### 10.3 Main Steam Supply System

The information in this subsection of the reference ABWR DCD, including all subsections, tables, and figures, is incorporated by reference with the following departures and supplements.

Figure 10.3-1 Main Steam Supply System

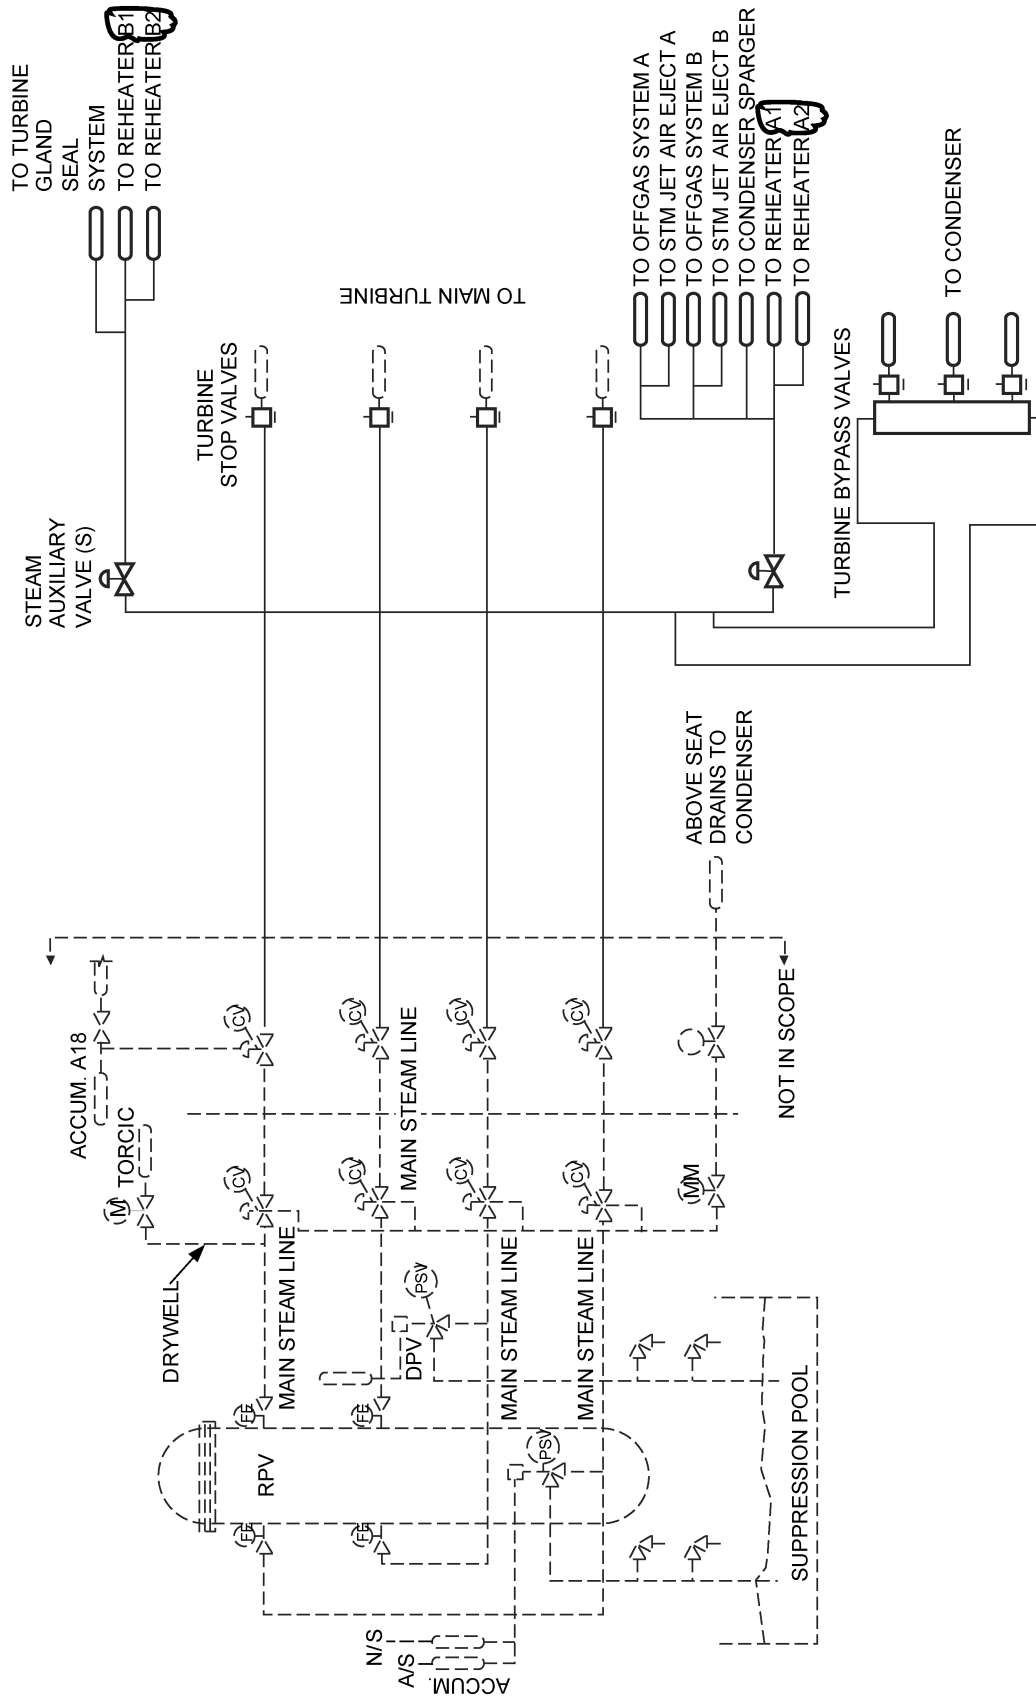
STP DEP 10.2-1 (Figures 10.3-1 and 10.3-2)

*The Main Steam Supply System is illustrated in Figure 10.3-1. The system design data is provided in Table 10.3-1. The main steam piping consists of four 700A pipe size diameter lines from the outboard MSIVs to the main turbine stop valves. The four main steamlines are connected to a header upstream of the turbine stop valves to permit testing of these valves ~~the MSIVs~~ during plant operation with a minimum load reduction. This header arrangement is also provided to ensure that the turbine bypass and other main steam supplies are connected to operating steamlines and not to idle lines. The main steam process downstream of the turbine stop valves is illustrated in Figure 10.3-2.*

Figure 10.3-2 Main Steam Turbine System

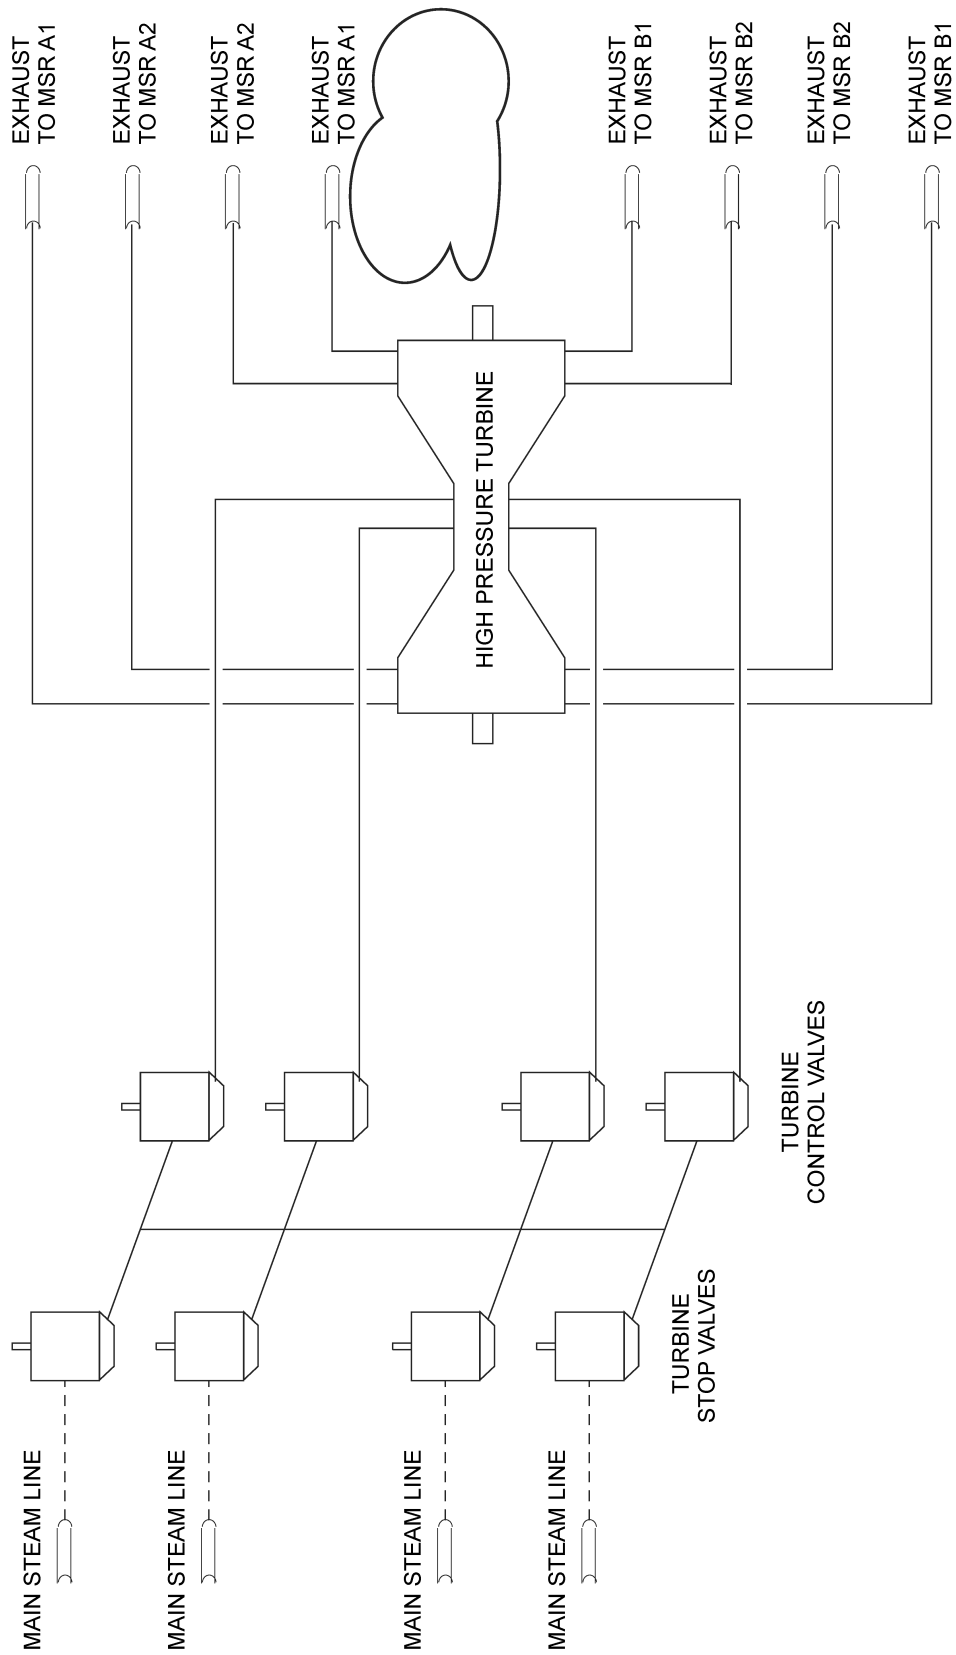
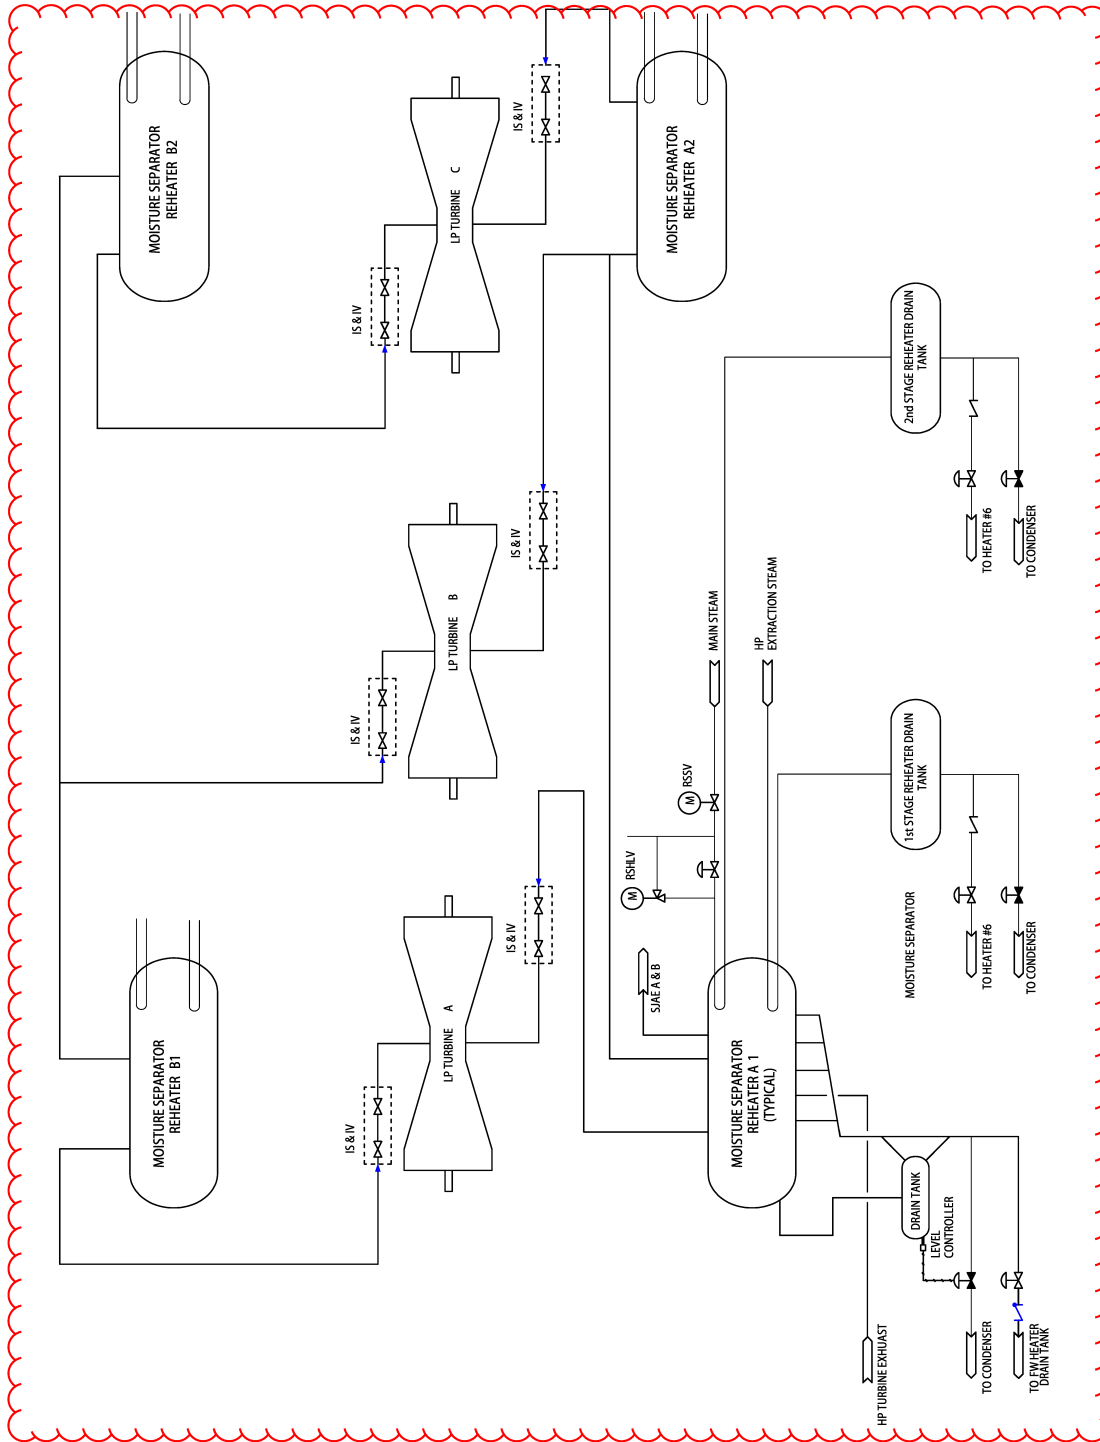
STP DEP 10.4-3 (Figure 10.3-2)
